13 October 2022

Natasha Homsey
Environmental Assessment Officer
Department of Planning and Environment

Liverpool Range Modification 1 (SSD-6696 MOD1)
Muswellbrook Shire Council – MOD1 Objection

Figure 1 – Proposed OSOM Transport Route for Liverpool Range MOD1 using Council owned Local roads

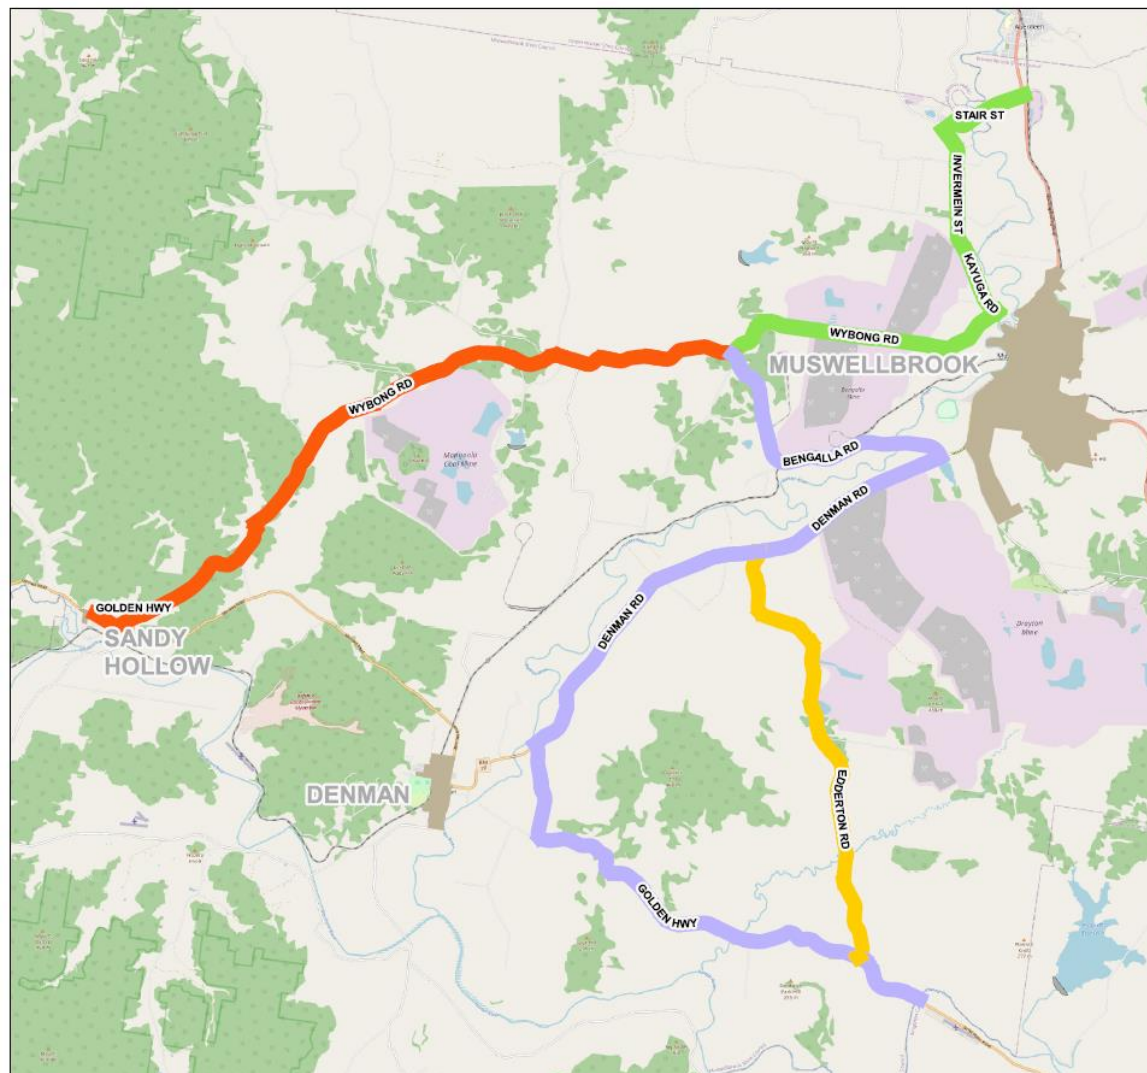
- Transportation of 90m wind turbine blades (and loads >5.2m height), originating at the Port of Newcastle, via the following Council local roads (**Figure 1**):
 - Bengalla Link Road;
 - Wybong Road; and
 - Edderton Road
- Proposed upgrades to the abovementioned roads to facilitate the movement of 660 Over Size Over Mass (OSOM) vehicles required to transport the blades; and
- Removal of up to 0.1ha of native vegetation from Wybong Road.

It should be noted that the transport route shown in **Figure 1** is currently being proposed as a transport route by up to five other similar projects in the CWO REZ.

1. Council has been approached by several renewable energy proponents seeking to use local roads to access the REZ's via the routes shown in **Figure 1** and **Figure 2**.
2. Currently, there are approximately 2,265 Over Size Over Mass (OSOM) (blade) movements proposed through the MSC LGA using Council owned local roads to access the CWO REZ. A review of the HNE REZ has not been undertaken.
